SEWAGE DISPOSAL SYSTEM

MARYLAND STATE DEPARTMENT OF HEALTH

03-282694

ADDRESS 12196 Triadelphia Road, Ellicott City, Md PHONE 988-9221

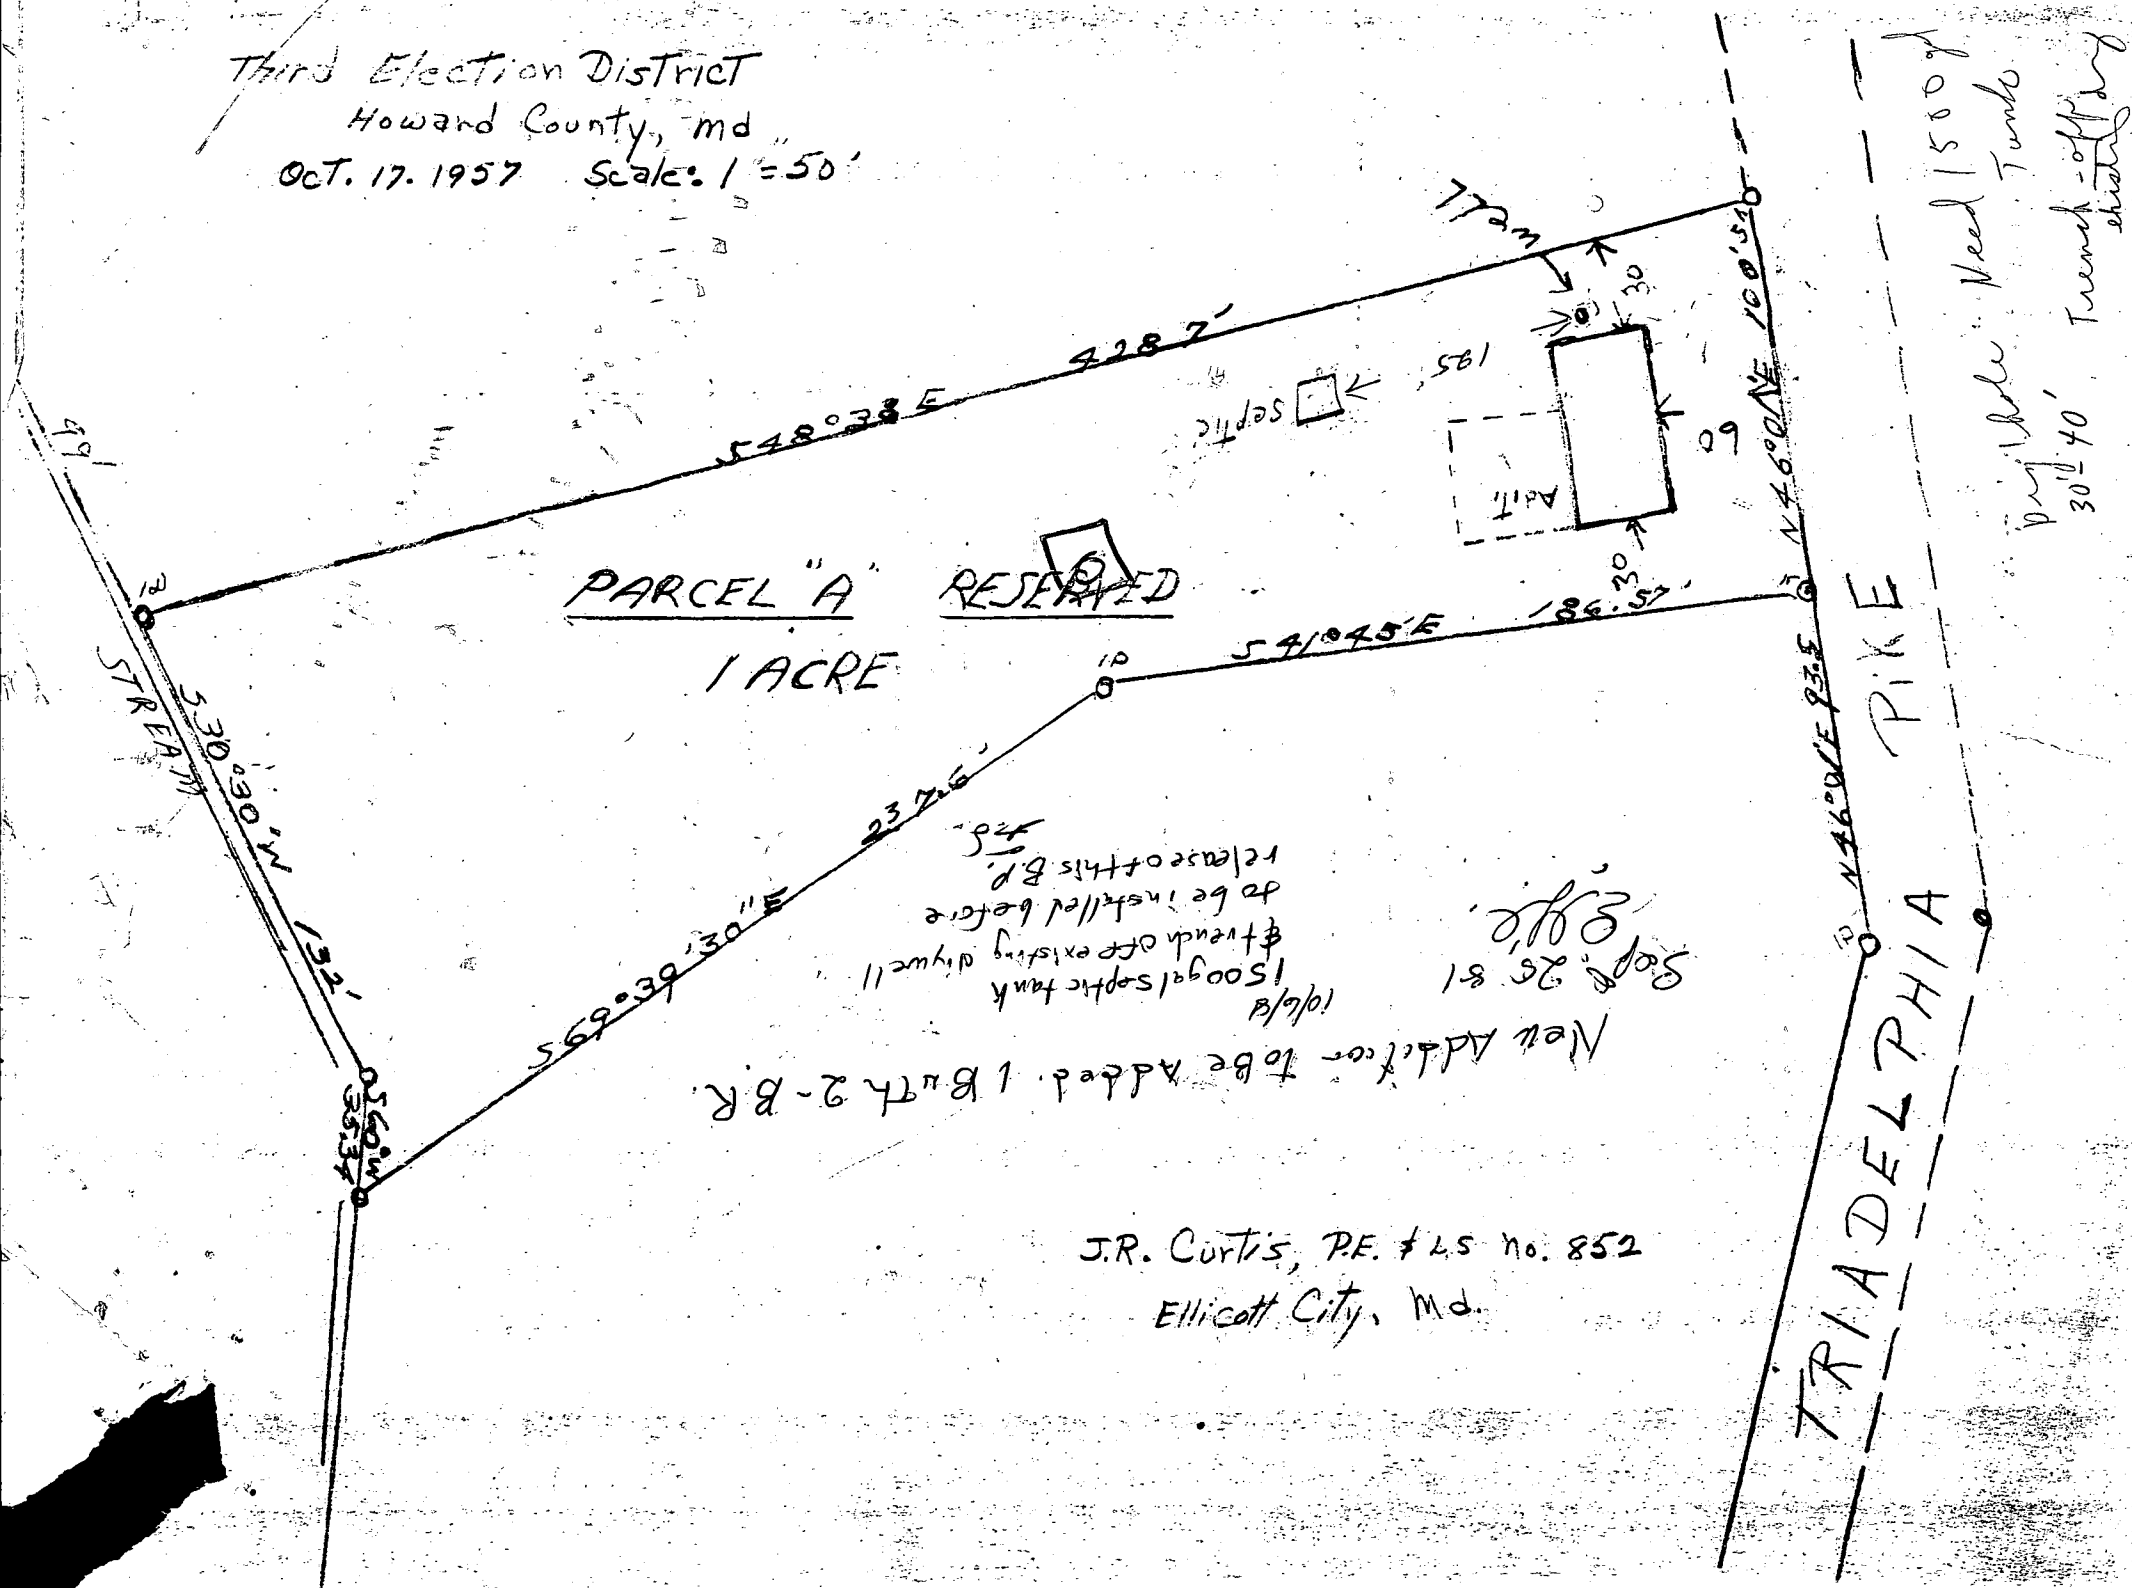
C.O. #1
TO GRADE
NEED PLUG
10/13/81

C.O. #2
TO GRADE
NEED PLUG
10/13/81

REMARKS 10/7/81 OK TO CONTINUE WORK - PARTIAL (2) NO CHANGE (3)

OK TO COVER PIPE FROM HOUSE TO TRK. NEED TO SEE CLEANOUTS
PLUGGED IN LINE; OK TO COVER FROM SEPTIC TANK TO DRYWELL
ONLY; NEED TO SEE SEPTIC TANK TOP AND CLEANOUT AND LINE FROM
DRYWELL TO TRENCH AND TRENCH. 10/13/81 OK TO COVER ALL

WORK EXCEPT NEED TO SEE CLEANOUT PLUGS IN LINE CLEANOUTS. PARTIAL
TO CALL FOR FINAL - TENTATIVE OK TO RELESS WLP. PERMIT C.B. + F.V. C.B.

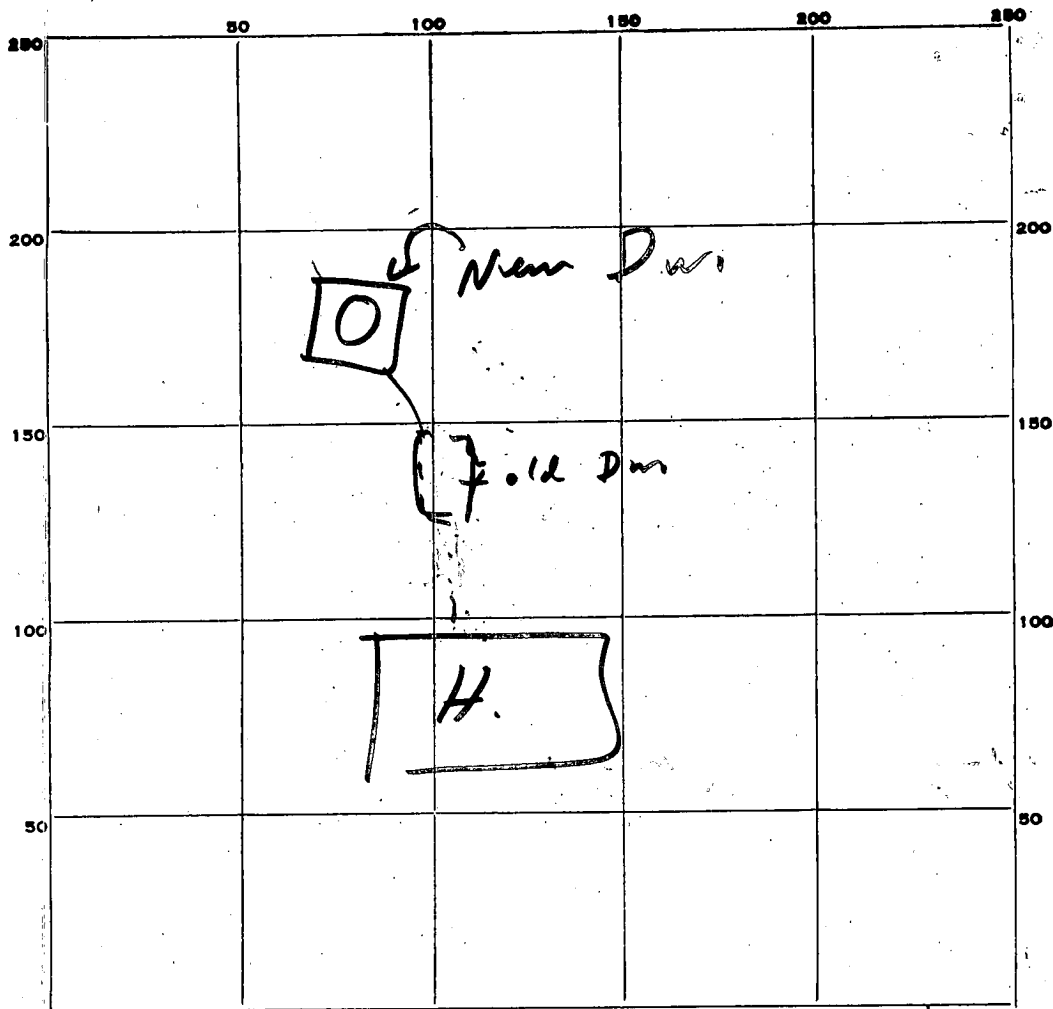
OTHER REPAIR - Dry well - to be inspected by Sanitarian.

At time of inspection drywell was dig 12 1/2 ft deep
and had 6-7 rows of blocks. Suggested that Mr. Cornwell
connect new well off of existing drywell. R.T.

3/11/74 Rex Luther of Catonsville Plumbing & Heating
did work. System completely covered now. I did
see cleanout for new D.W. WWZ.

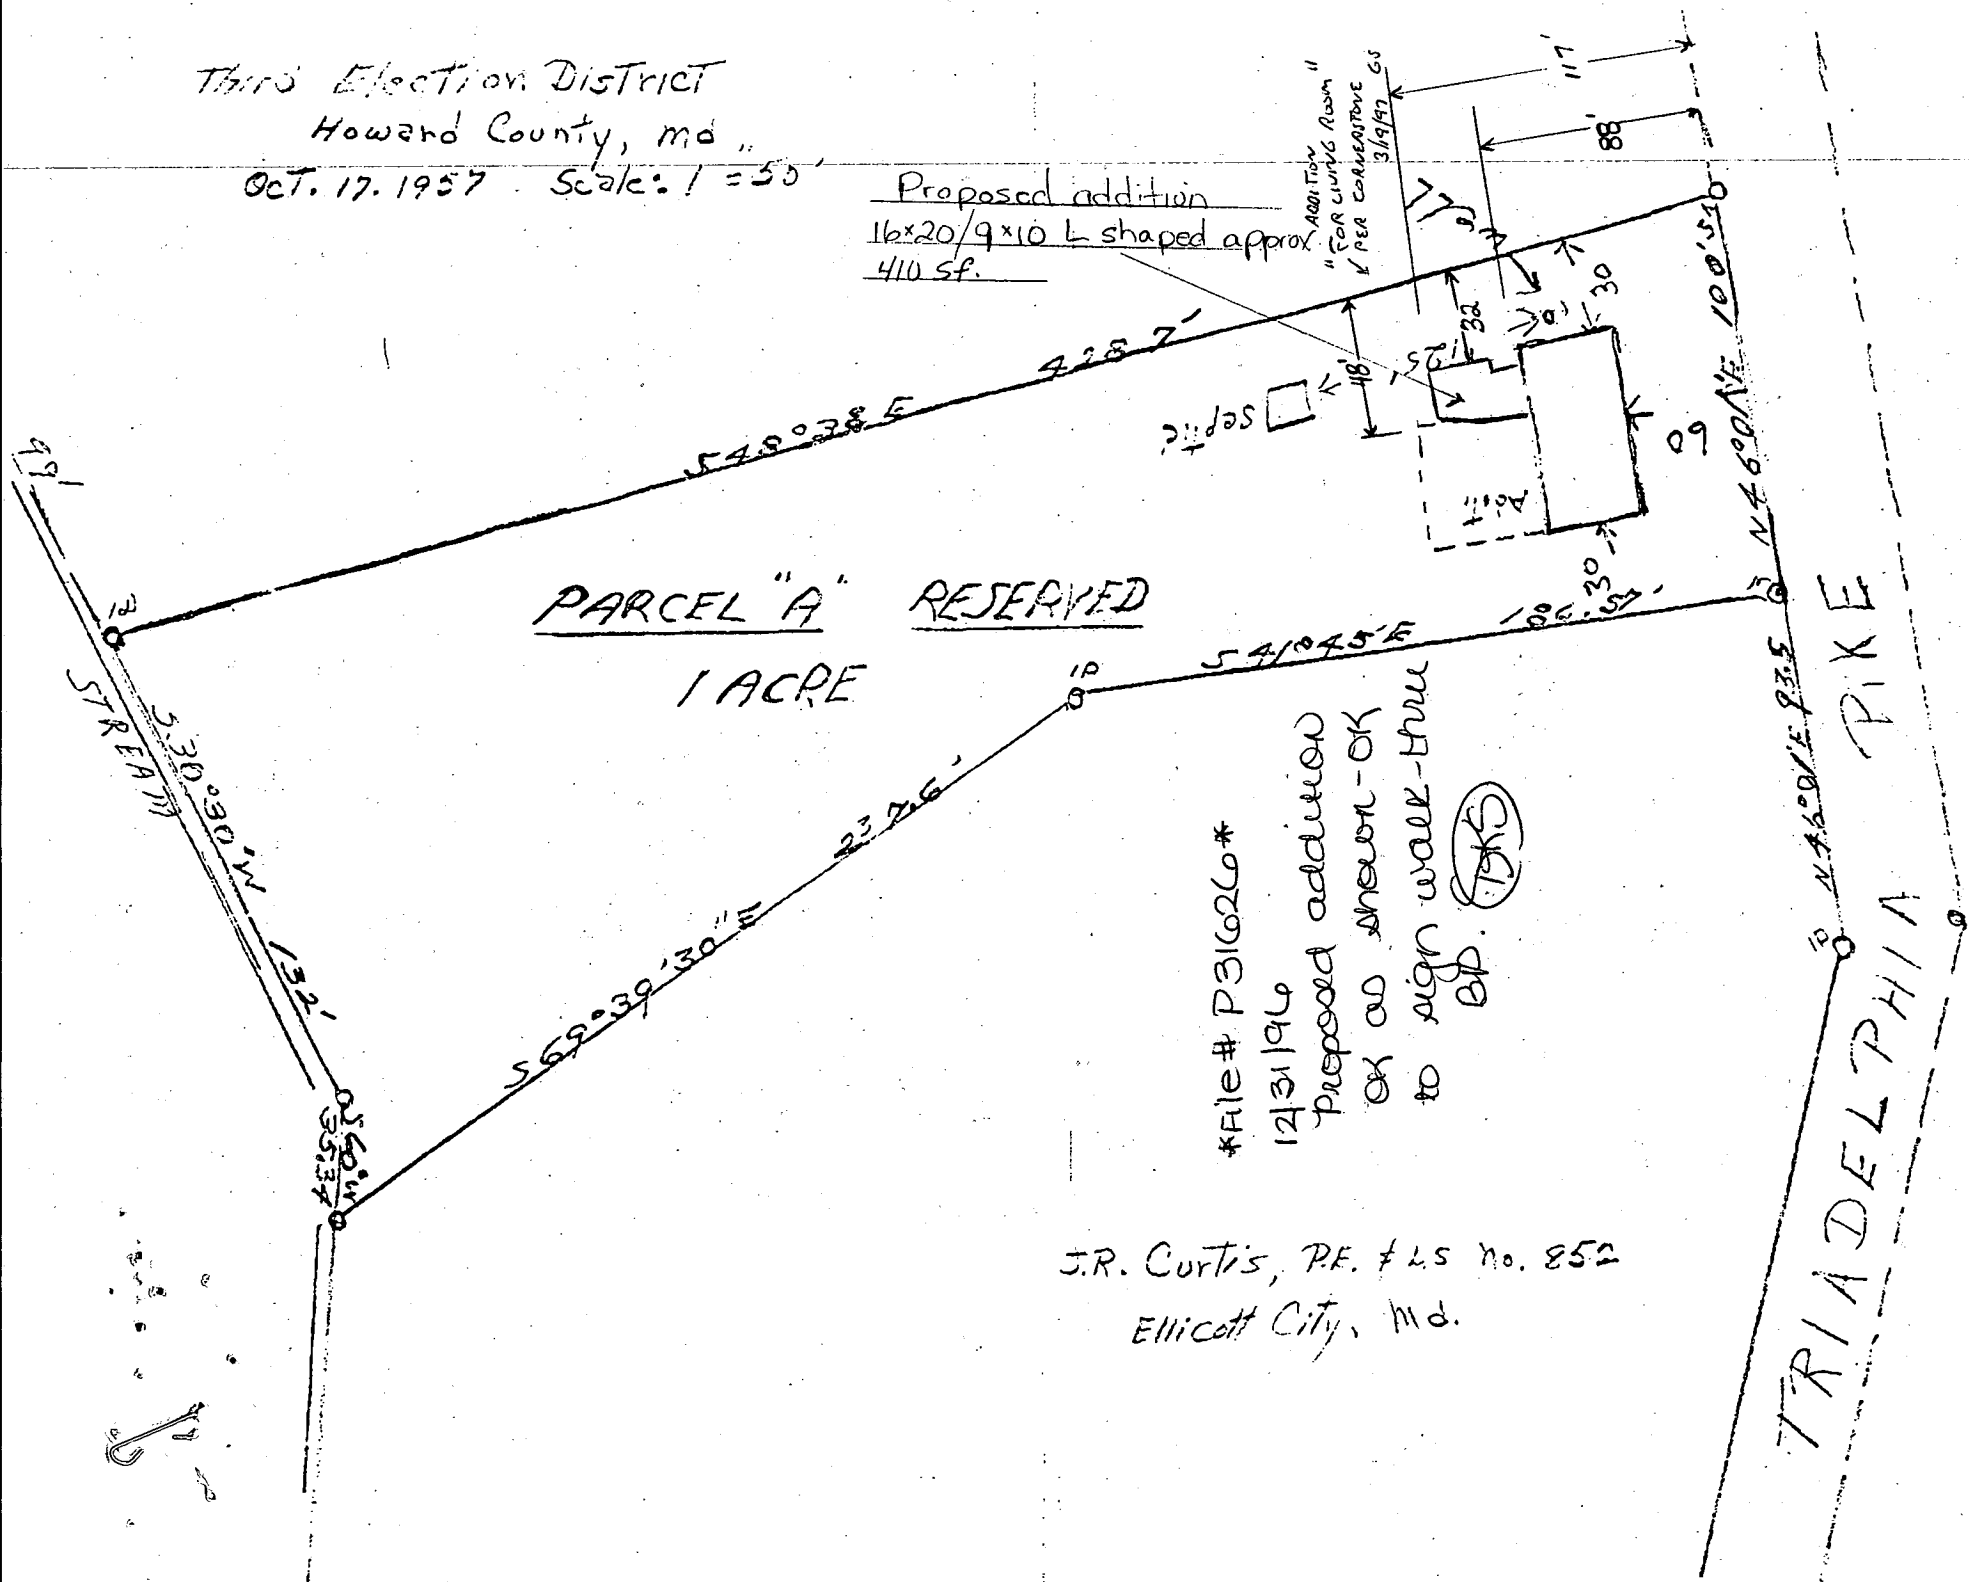
Proposed addition
16x20/9x10 L shaped approx.
410 sf.

Proposed addition

OK as shown - OK

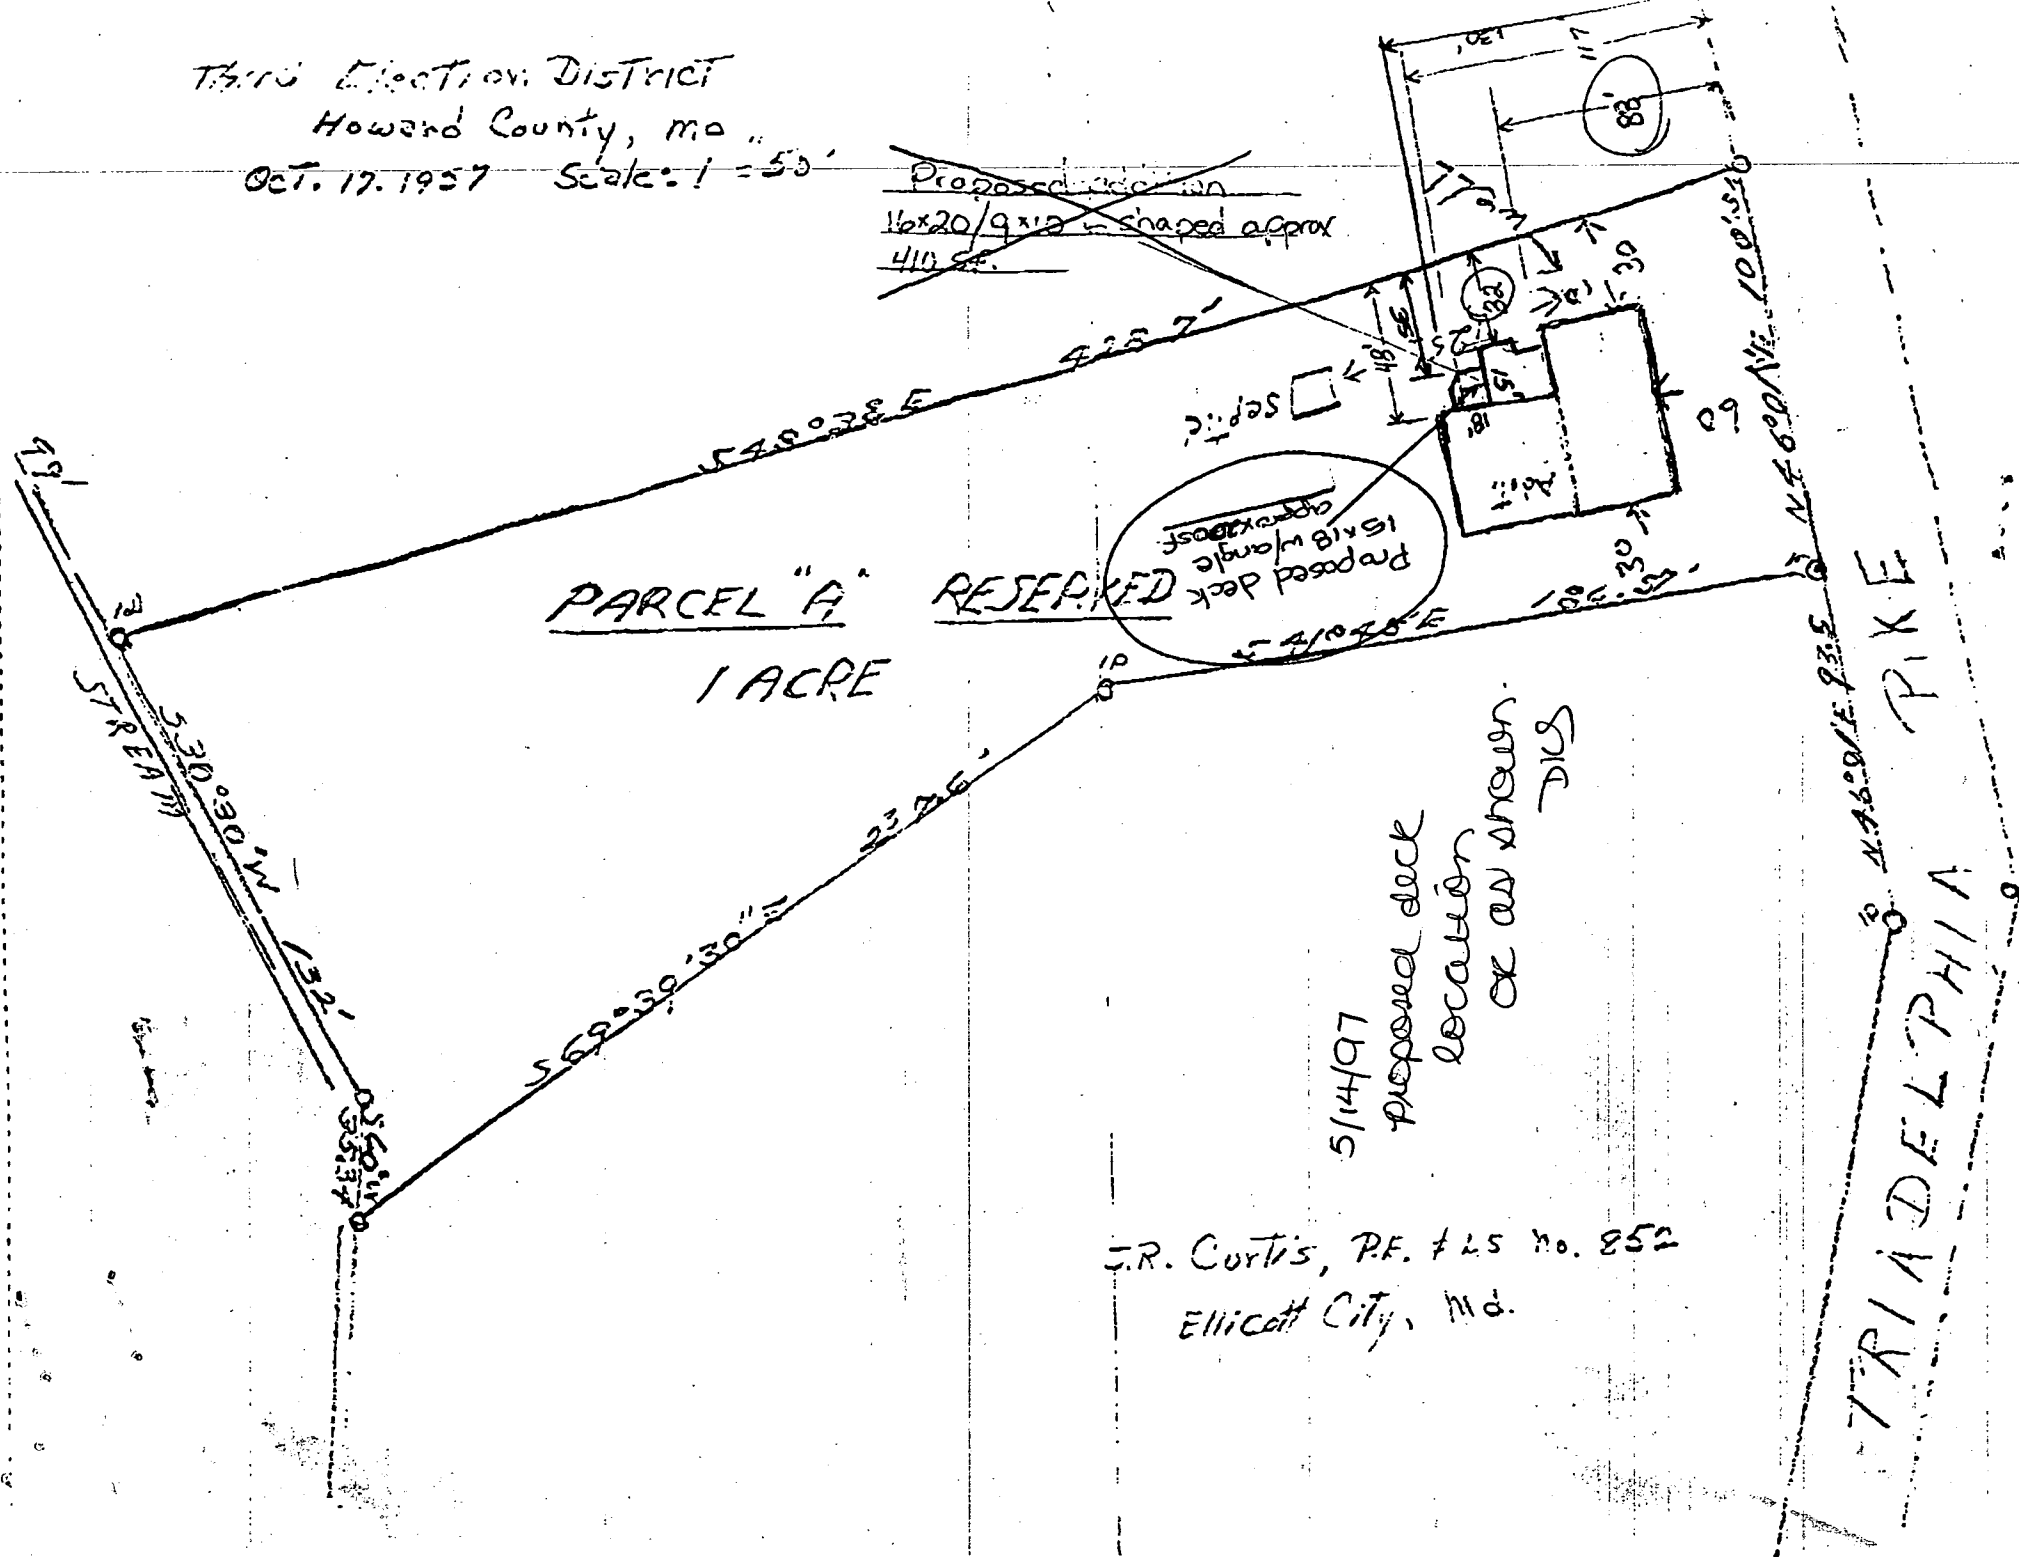
~~Proposed deck on
16x20/9x12 shaped approx
410 sq. ft.~~

Proposed deck
15x18 w/angle
approx 150°

5/14/97
Proposed deck
location
as shown
DLC
